**REDSTONE GATEWAY PACKAGE 1F REDSTONE GATEWAY  
EXTENSION, MARKET STREET, AND OVERLOOK ROAD  
RELOCATION**

**Project No. 65-11-SP22  
September 30, 2011**

**Addendum #1**

**C3.1**

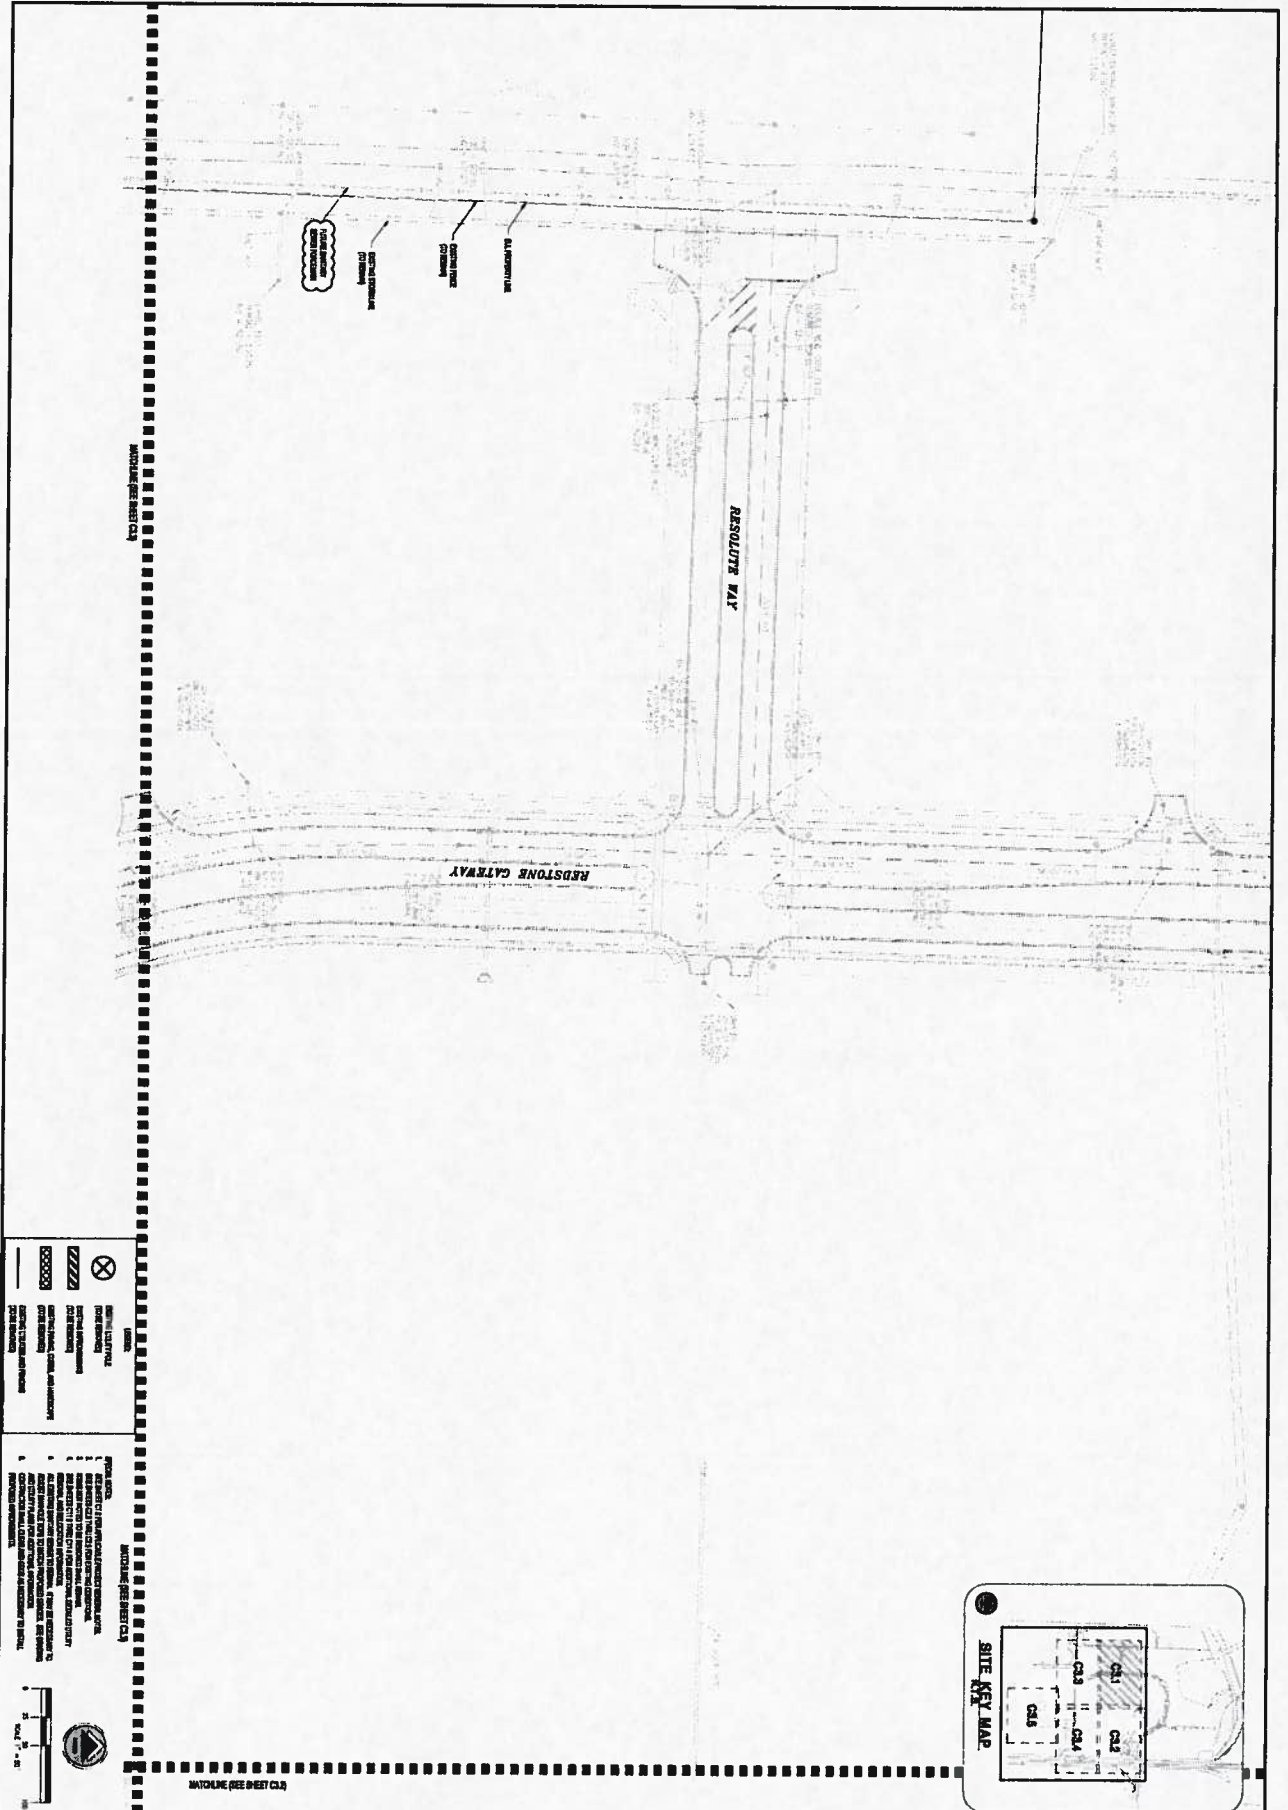
A. This will awarded in a future bid package.
6. Q. Is there any special bid bond form?  
A. No.
7. Q. On the demolition plans C3.1 through C3.5, there is a lot of fencing noted to be removed. Some of it says to be "removed" and some of it (along the north side of the road) is noted to be "salvaged to owner". Please verify only the fencing noted to be salvaged is indeed to be salvaged (and not all fencing).

**Sheet C2.1, C2.3 & C3.1** - Revised sanitary sewer force main to be “future” instead of “existing”.

A. All security fencing is to be salvaged. The barbed wire fencing should be removed.
8. Q. Please clarify to what extent you want the fence materials salvaged - i.e., fabric to rolled.

A. The top rail, bracing, stretcher bars and metal mesh shall be stored on-site at a location directed by the City Project Manager. Fence posts shall be removed off-site at Contractors expense.

C9.6

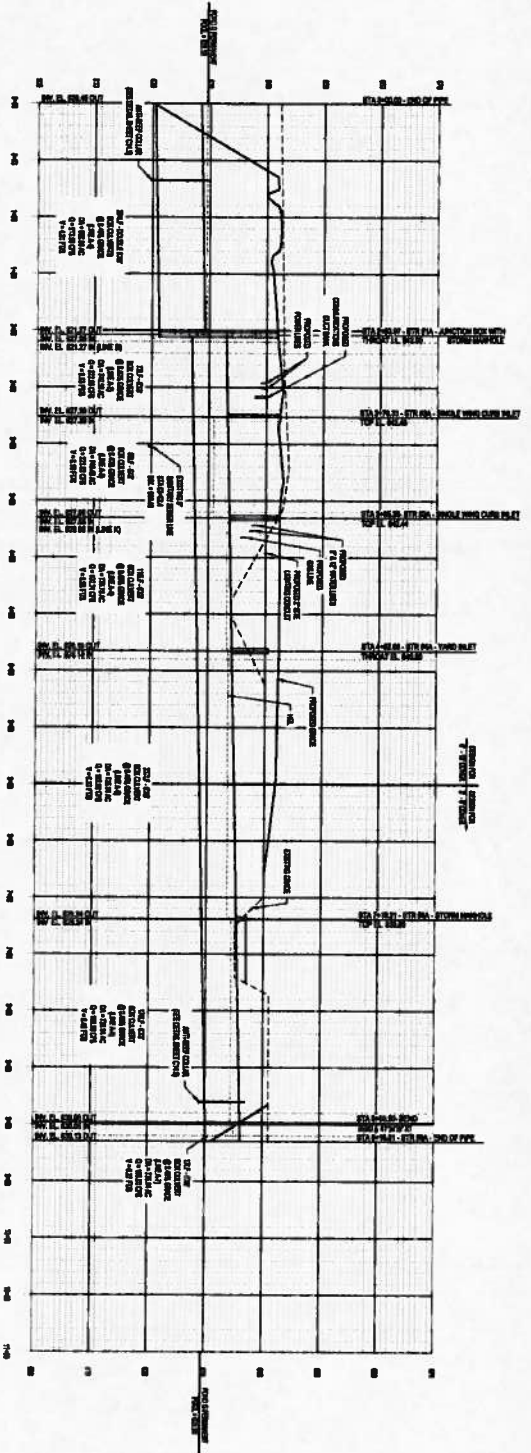
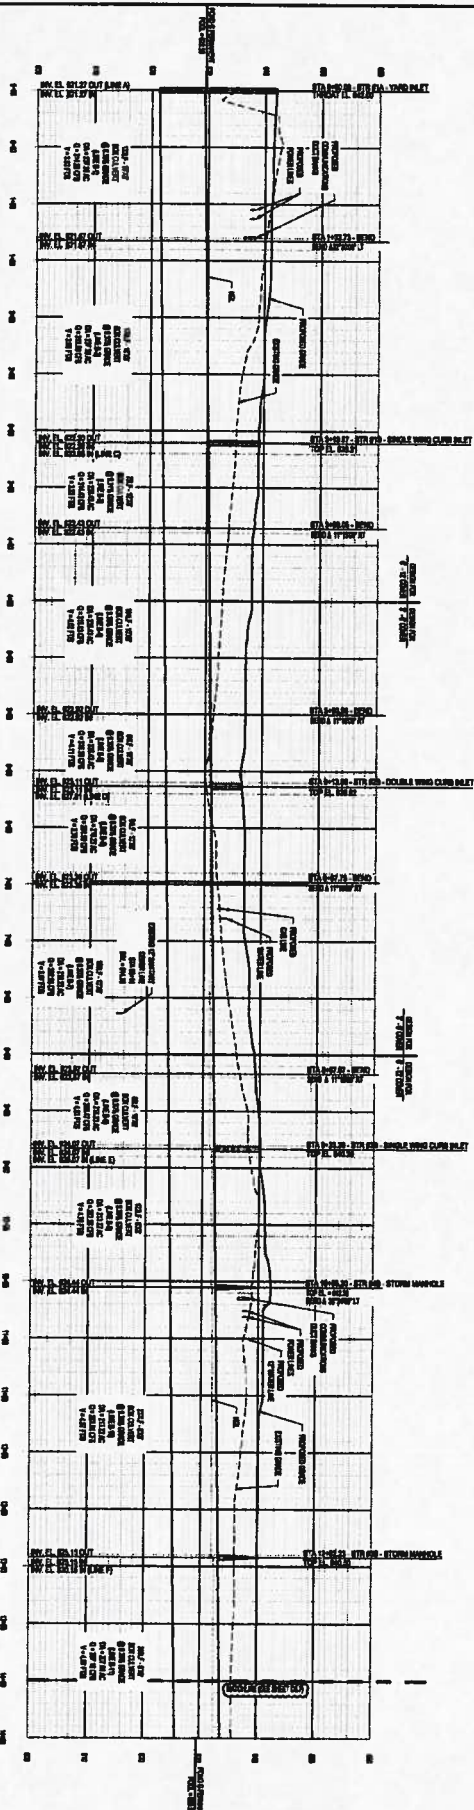
**Sheet C9.6 – C9.7** - Revised match line references for Storm Line B.

**C11.2**

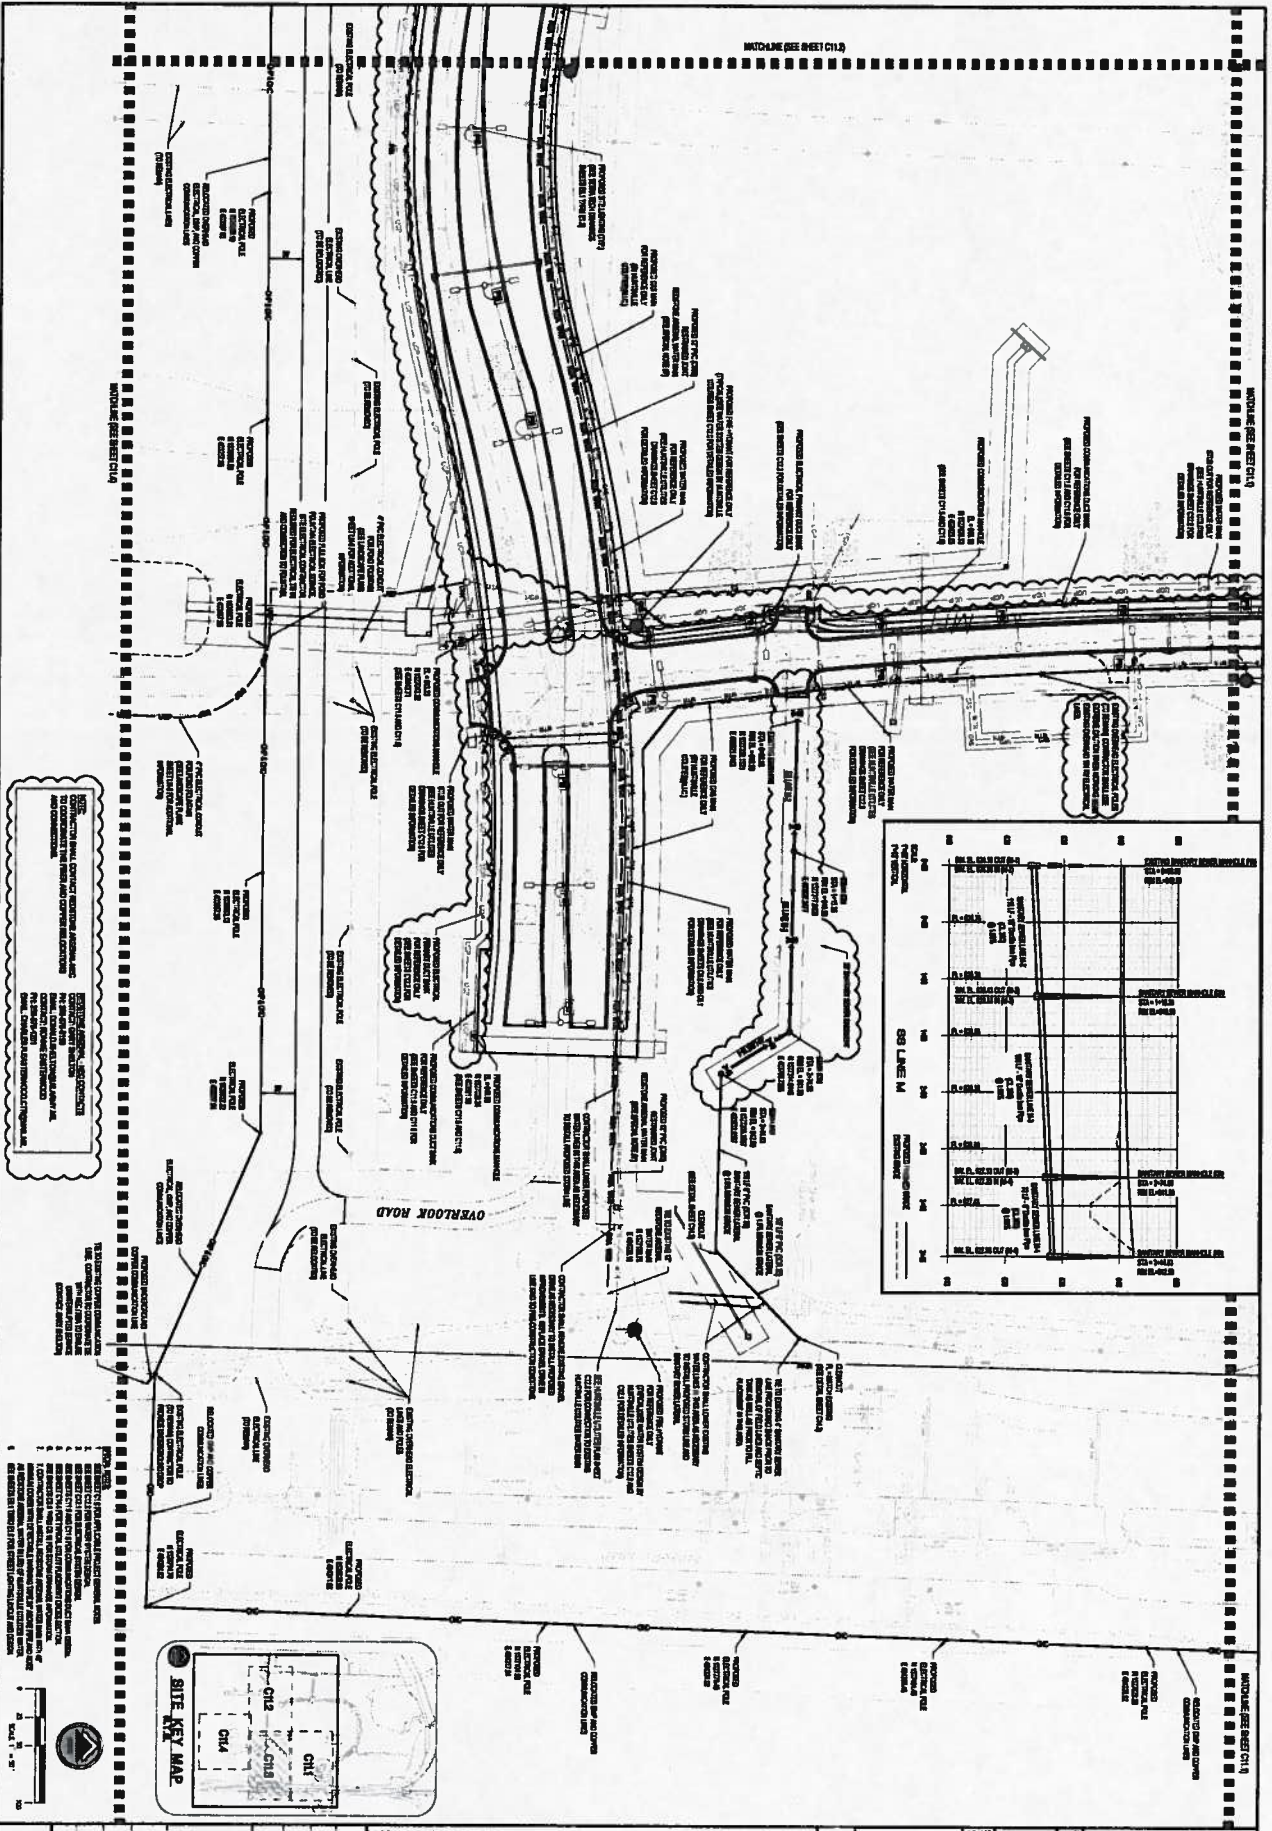
**Sheet C11.0, C11.1, C11.2** - Revised proposed HU power layout to be within the utility and drainage easement. Revised the location of some of the electrical cabinets and switch gear. Added note to contact RSA-NEC to coordinate the relocation and connection of fiber and copper lines.

**JUNCTION BOX DETAIL-STR #1A**

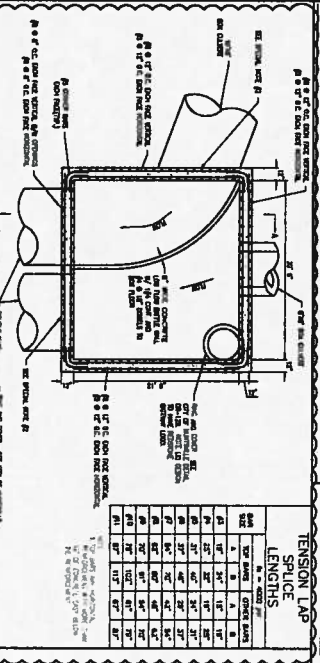
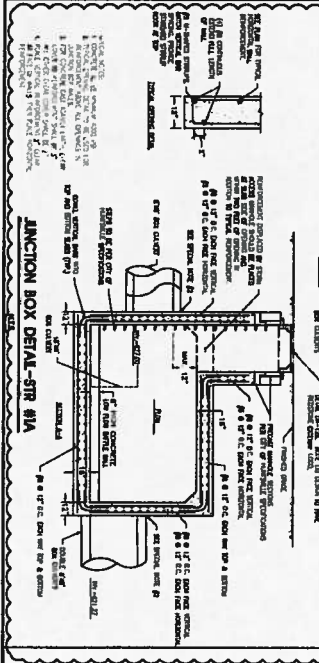
**Sheet C14.4 - Revised Junction Box Detail – STR#1A.**

**C14.9**

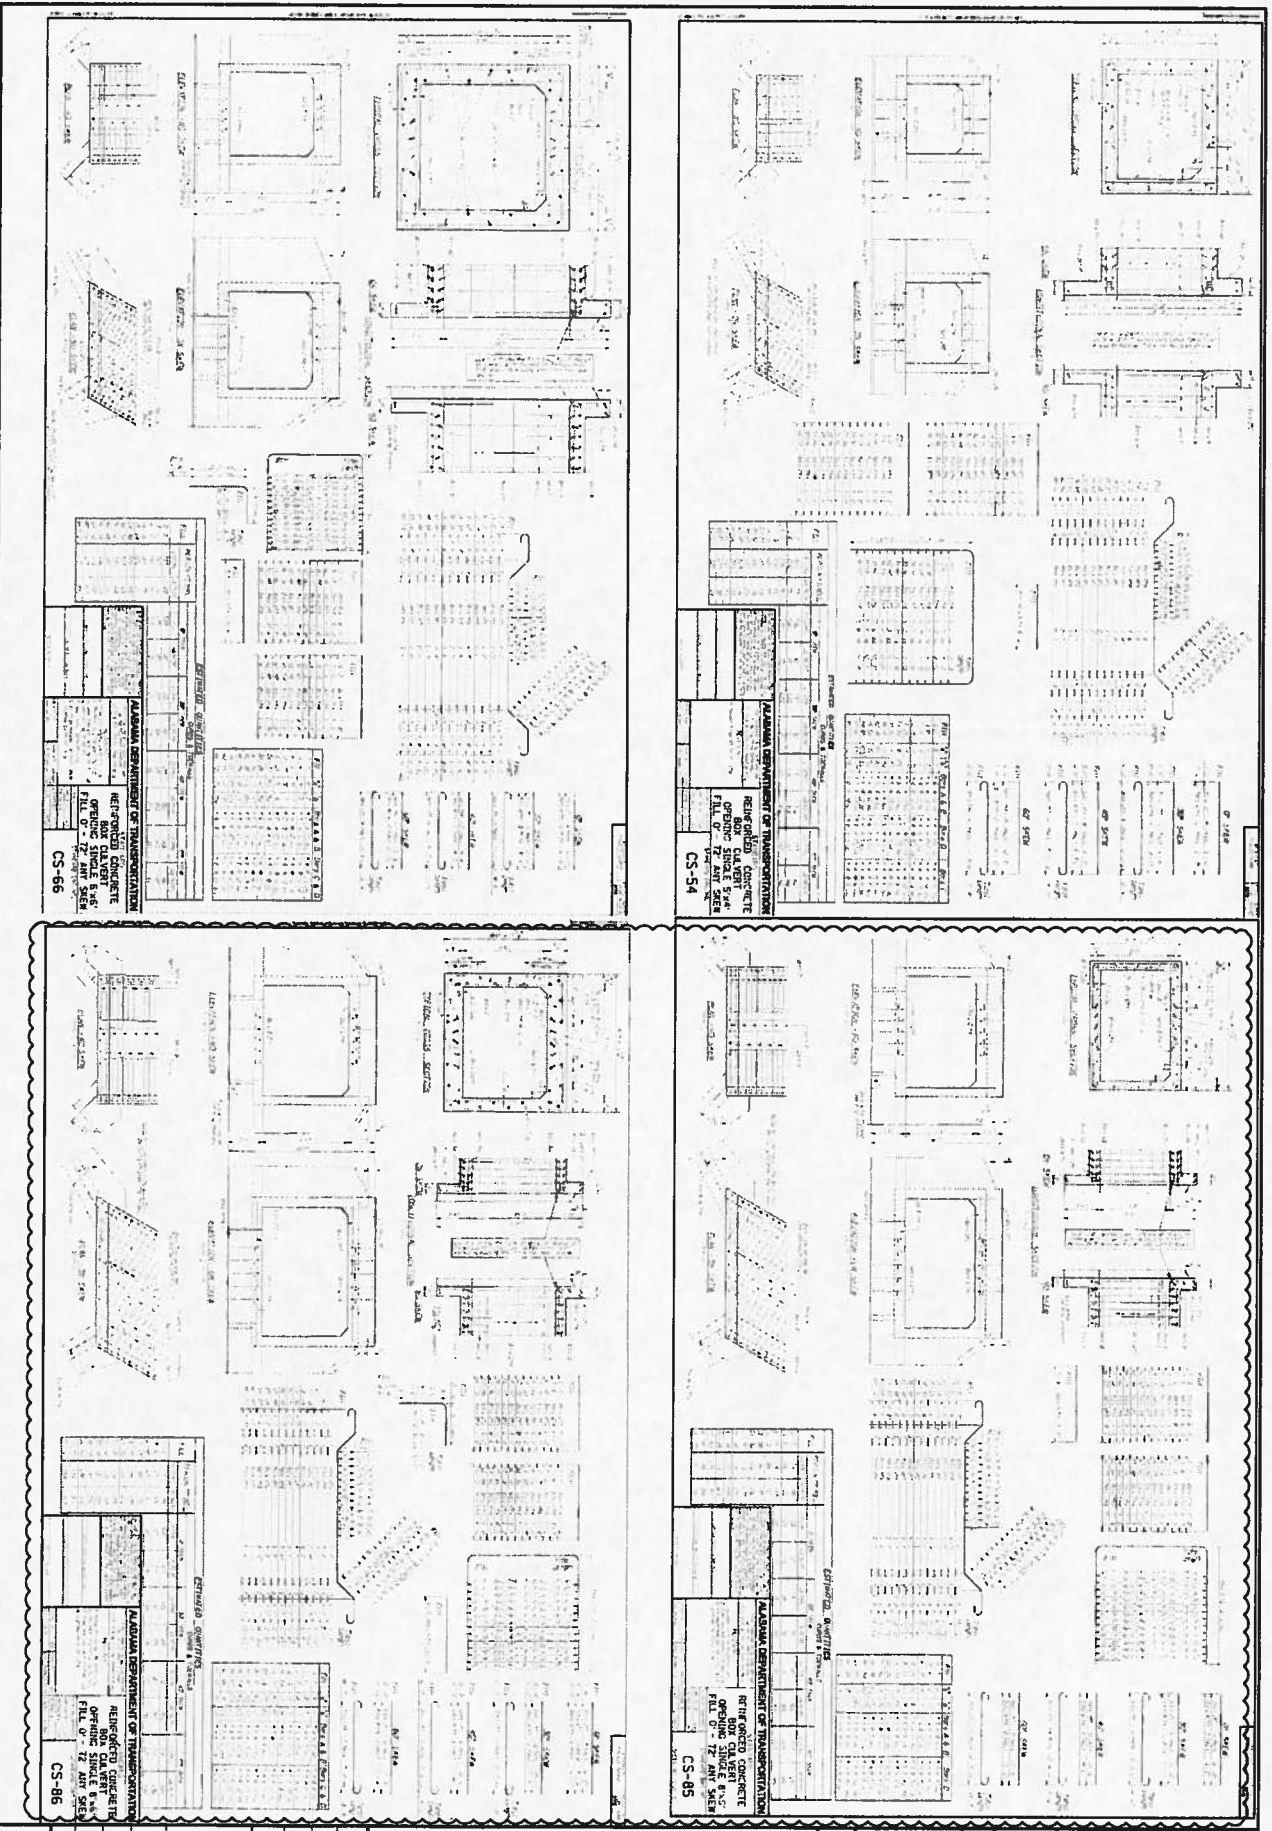
A. Match the tops.
15. Q. There are culvert details on the drawings for culvert sizes that are not shown on the drawings?  
A. Additional details will be issued in Addendum #1 to clarify the scope for box culverts.

**Sheet C14.9 - Removed details for 7'x6' box culvert and 6'x5' box culvert. Added details for 8'x6' box culvert and 8'x5' box culvert.**
